Comments on Matters 1.6 section 1.6.8

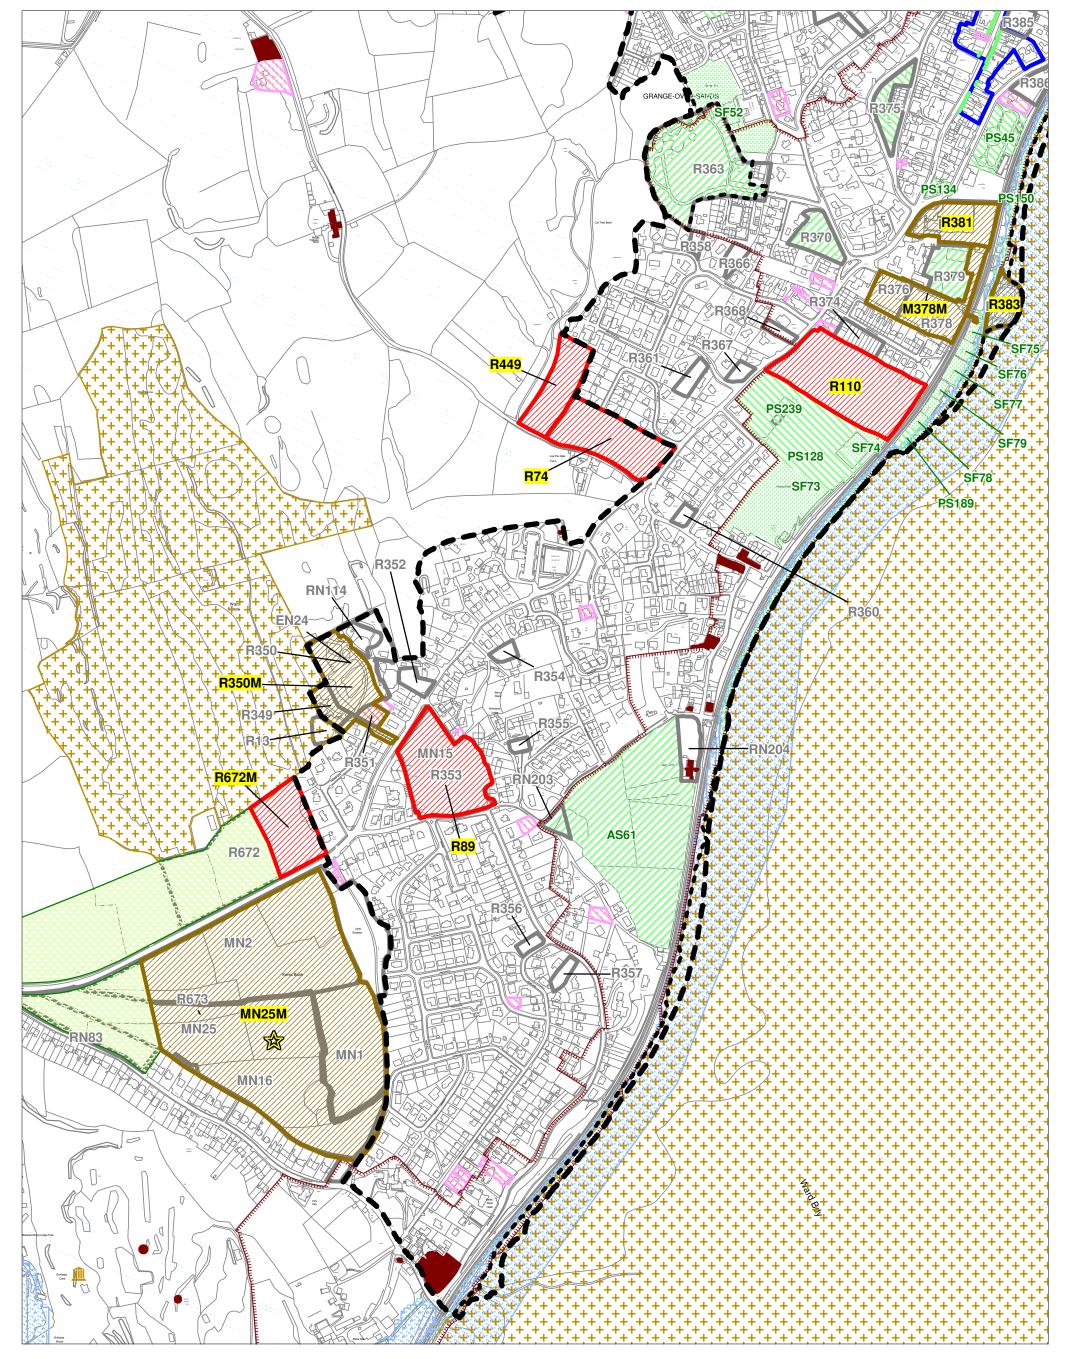
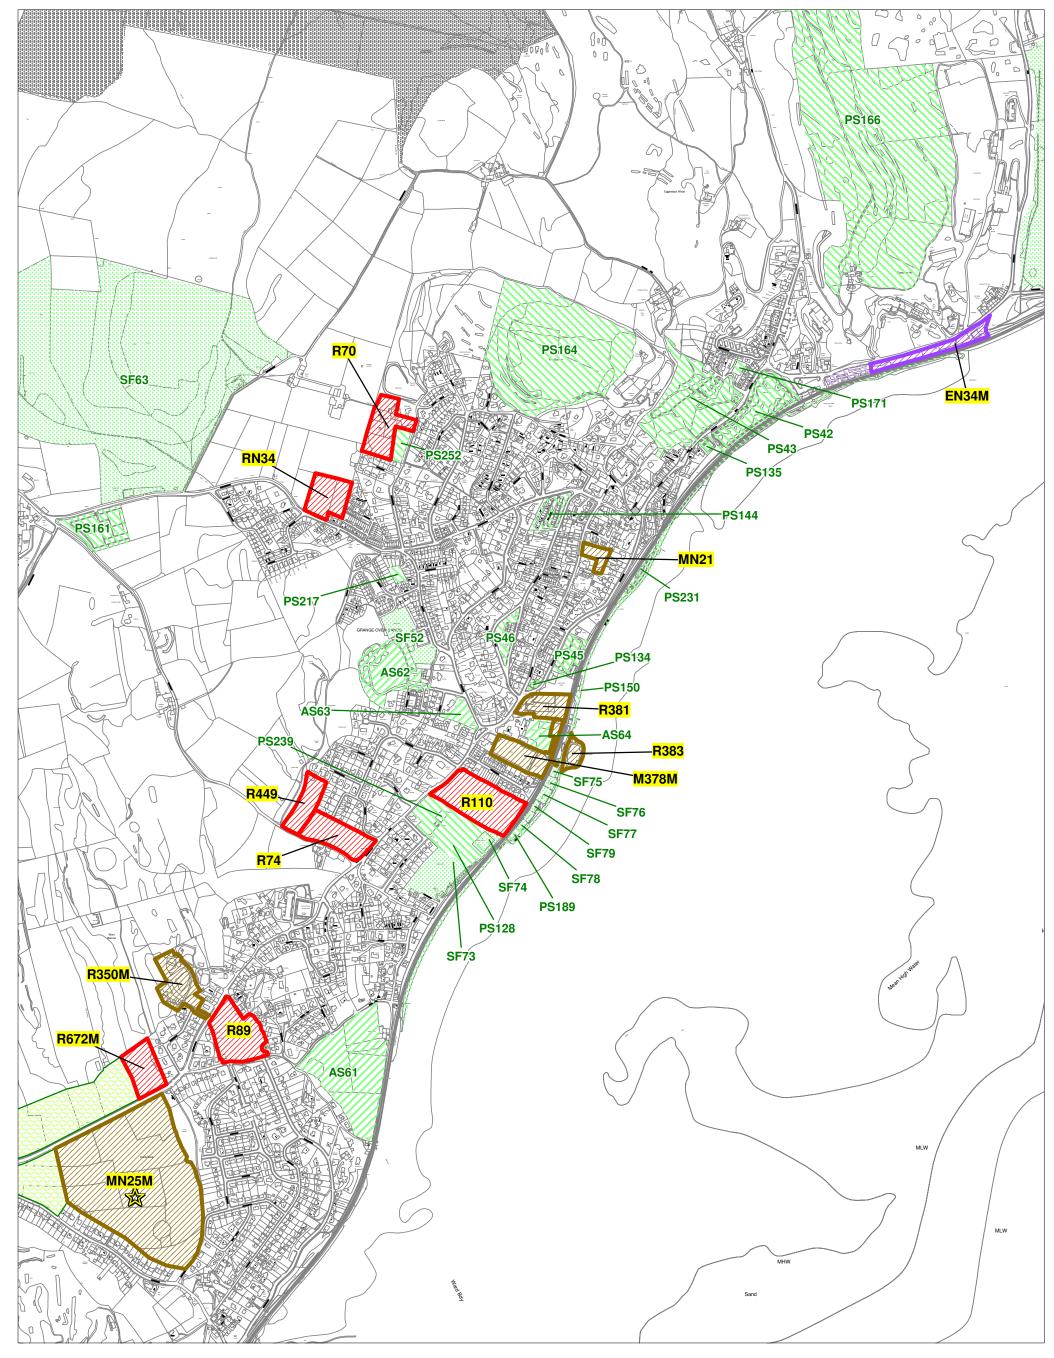
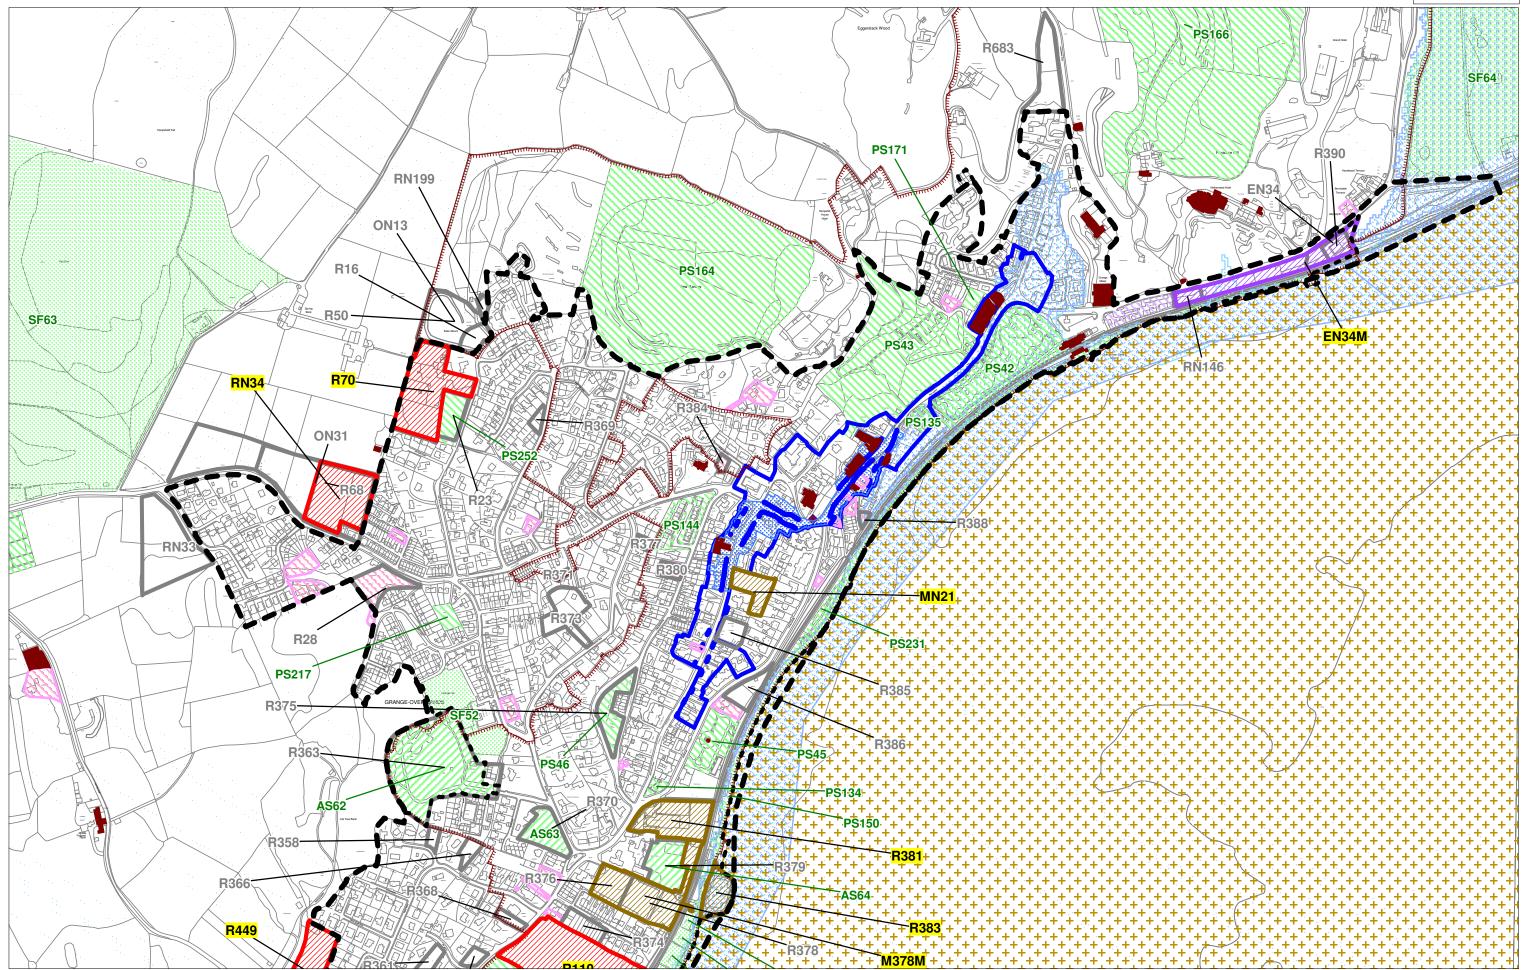
All sites were considered on the same assessment criteria, but when looking at the spread sheet for Grange under Summary of Assessment for site R68, R350, R672M and R89 we find that:-

R68 is stated as on the edge of Grange and the site is some distance from Granges services and facilities

R350M / R350 is stated as within Granges development boundary and the site is some distance from Granges services and facilities

R672M is stated on the edge of Grange and the site is some distance from Granges services and facilities. This site is within 200 metres of R89.

R89 is stated as within Grange and the site is relatively close to Granges services and facilities

These statement are incorrect as can be seen by SLDC's own maps. This is not the first time that R89 has been deliberately misrepresented in order to justify inclusion within the LDF.

This method of assessment and "scoring" can be seen as biased and seriously flawed when the above sites are examined.
